Subject: **Review of Revised Plans**
Proposed New Residence
6950 Southeast Maker Street
Mercer Island, Washington

Subject: **Slope Stability Update**
Proposed New Residence
6950 S.E. Maker Street
Mercer Island, Washington

As a part of the 2207-019-SUB1-PLANS REVIEW by City of Mercer Island, their geotechnical third-party reviewer made the following comment:

Static

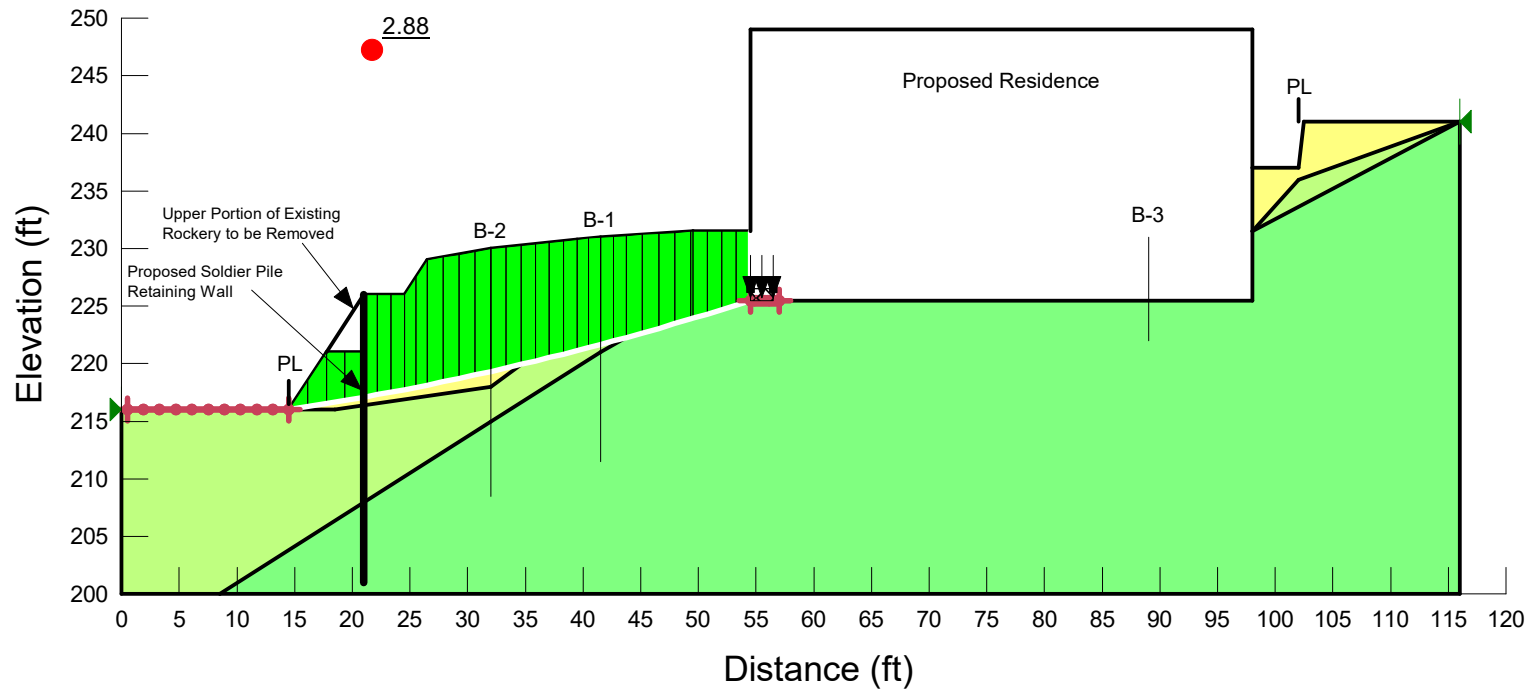
Based on our previous stability assessments, a theoretical failure could have extended through the toe of the existing rockery in the event of the low probability Maximum Considered Earthquake. The stabilization piles should be designed to resist active and seismic earth pressures to that depth, with passive soil pressure in the competent glacial till resisting the lateral earth loads below that depth.

F of S: 2.88

Seismic

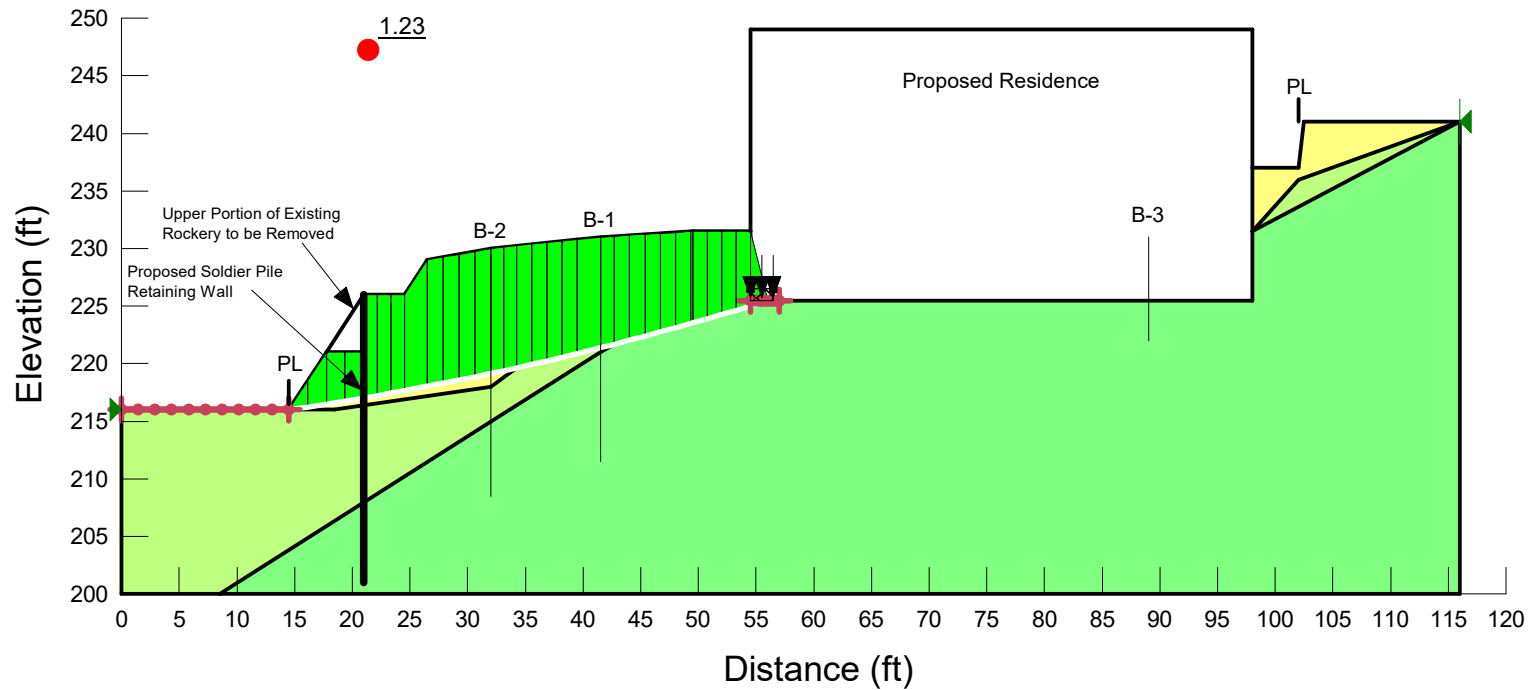
With you and your design team, we have discussed several different methods to provide stability of the fill behind the western rockery under both static and seismic (Maximum Considered Earthquake with a 2% chance of occurring in 50 years) conditions. Based on these discussions, and our review of the site conditions for equipment and truck access, it appears most practical to install a line of closely-spaced stabilization piles immediately behind the western rockery. These piles would retain the loose fill soils behind the rockery and provide stability for the fill in the event of an earthquake. In conjunction with the construction of this stabilization wall, the uppermost 4 to 5 feet of the existing rockery would be removed. This will create a level bench for the installation of the drilled piles. The upper 4 to 5 feet of the stabilization piles would then be lagged and backfilled to restore the ground surface elevation in the western yard area.

F of S: 1.23
